Front Spring Breakage
VAH**SP 721-005, Front Spring Breakage**

(October 2013)

W7084034

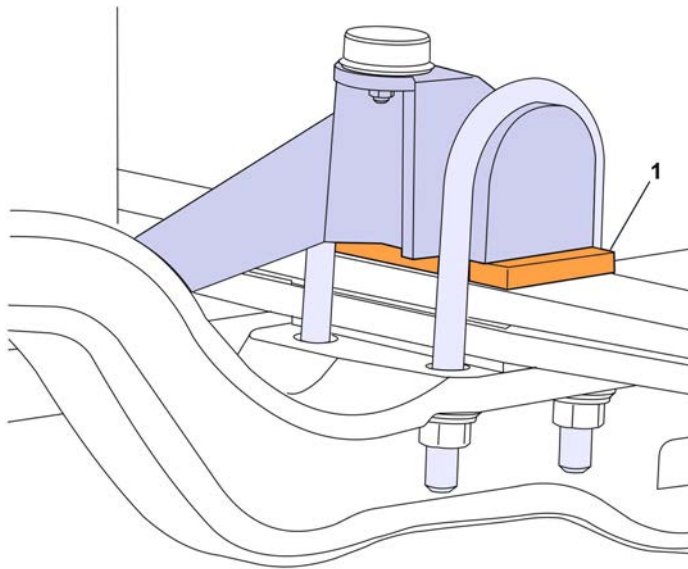
It has been discovered on some VAH vehicles that the front springs can over travel. Over time this can lead to breakage of the spring leaf. A spacer plate will be installed to increase the height of the suspension bumpstops to limit spring travel.

- 1 Spacer to be added between top plate and leaf spring.
 - 7 Remove the top plate over the spring assembly.
 - 8 Install the new spacer onto the spring assembly.
 - 9 Install the top plate, new U-bolts and nuts and secure. Torque to 550 ± 25 Nm (406 ± 18 ft-lb).
- Note:** Tighten evenly in an X - pattern.
- 10 Install the lower shock mounting fastener. Torque to 415 ± 40 Nm (306 ± 30 ft-lb).
 - 11 Perform these same steps on the other side of the vehicle.
 - 12 Jack the steer axle up and remove jack stands and let axle down.
 - 13 Remove wheel chocks.
 - 14 Lower hood.
